Z-30
(2010)

REZONING PLAN

DATE: 7/20/10
 PROJECT: CO-103
 DISTRICT: 1ST
 LAND LOT: 29
 COBB COUNTY, GEORGIA
 TIFANY PLACE UNIT III

PETITION NO: Z-30

REZONING PLAN

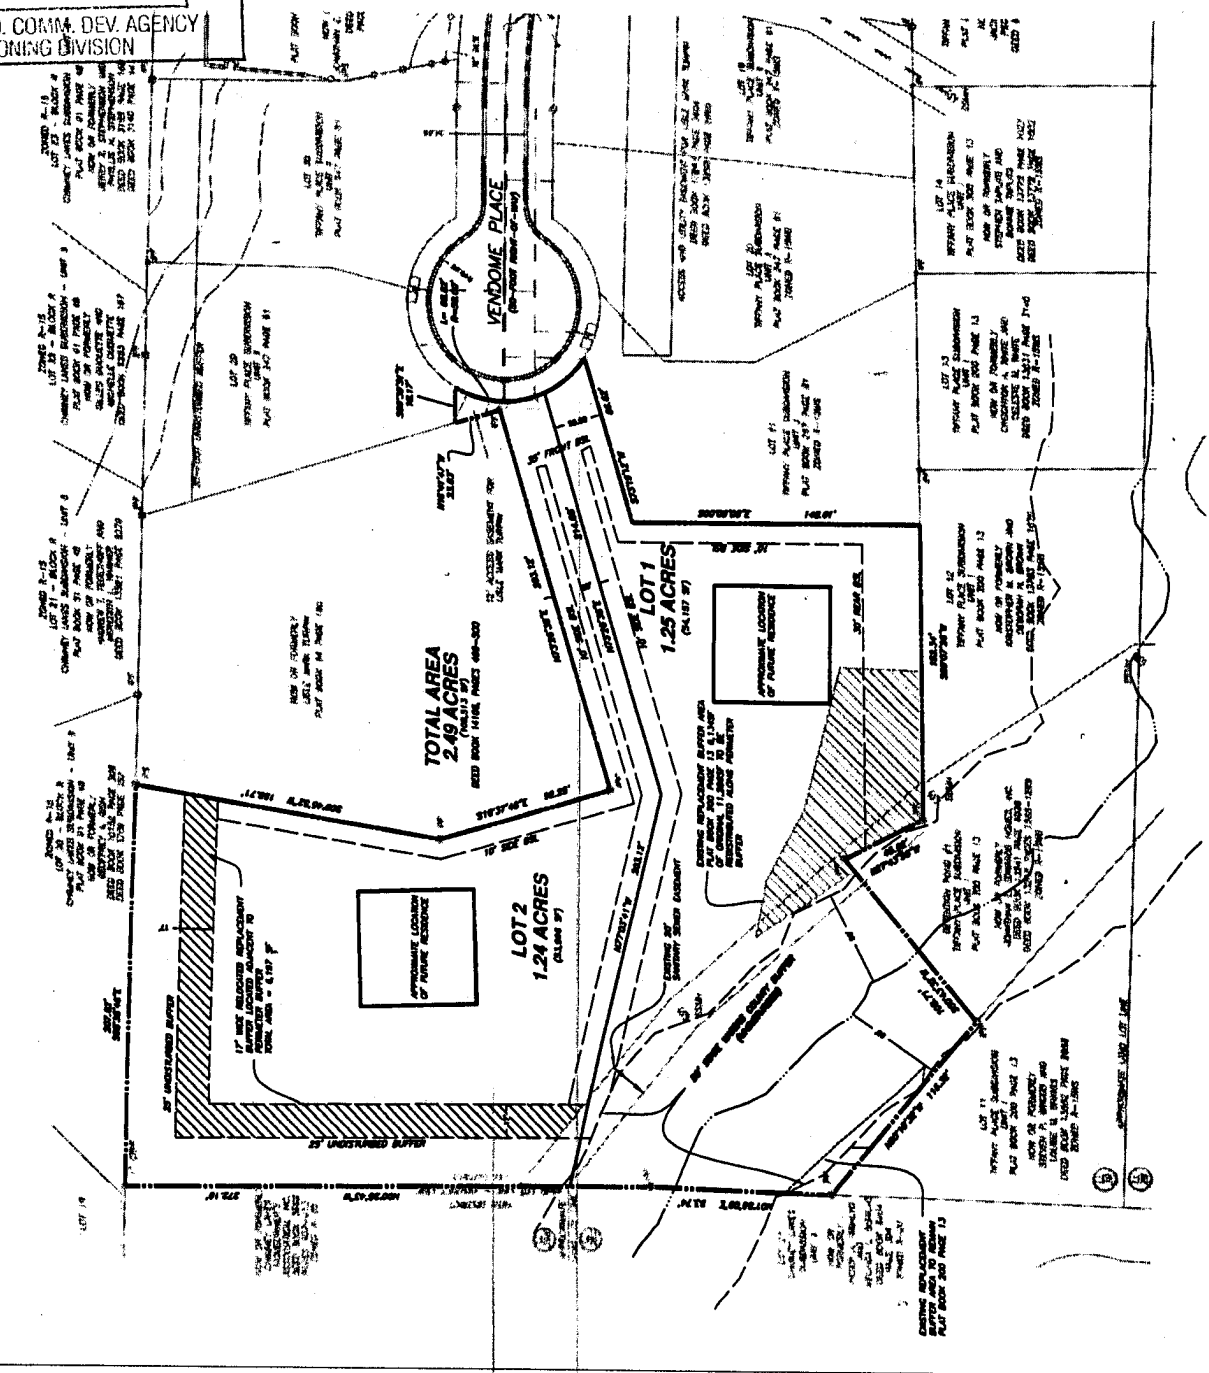
The applicant is requesting the R-15 zoning district to change the approved site plan and delete a lot on this property. Additionally, approximately 300-feet of roadway would not have to be built. The subject property was rezoned in 2003 to add property to the previously approved 14.37-acre R-15 subdivision (see Exhibit "A"). The proposed homes would be traditional in styling and would have a minimum of 4,500 square-feet. The homes are anticipated to start selling for \$500,000, and up. The 25-foot undisturbed buffer along Chimney Lakes subdivision will be increased to a 42-foot undisturbed buffer. The applicant would need a contemporaneous variance to allow the two lots to have 25 feet of public road frontage in lieu of the required 50 feet of public road frontage.

Both of these proposed lots are located on steep slopes ranging from 17 to 28%. A site grading plan should be submitted to the Stormwater Management Division prior to permitting to verify that grading does not encroach into undisturbed buffer areas and that no concentrated discharge points are created.

- Driveway must have a minimum 12' driving surface width with minimum 25' inside turning radius.
 - Fully developed landscaping shall be at least 7'0" from center of drive (14' clear width) and 13'6" vertical clearance. (Indicate on plan minimum setbacks).

Size / Location of Existing Water Main(s): 8" DI / S side Vendome Place

Additional Comments: Meters to be set at Vendome Place ROW

Additional Both lots must connect to sewer
Comments:

Shared drive for lots fronting Vendome Place.

Recommend shared driveway access.

- Site plan received by the Zoning Division on August 5, 2010;
- 42-foot undisturbed buffer along northern and western property line;
- Water and Sewer comments and recommendations;
- Stormwater Management comments and recommendations; and
- DOT comments and recommendations.
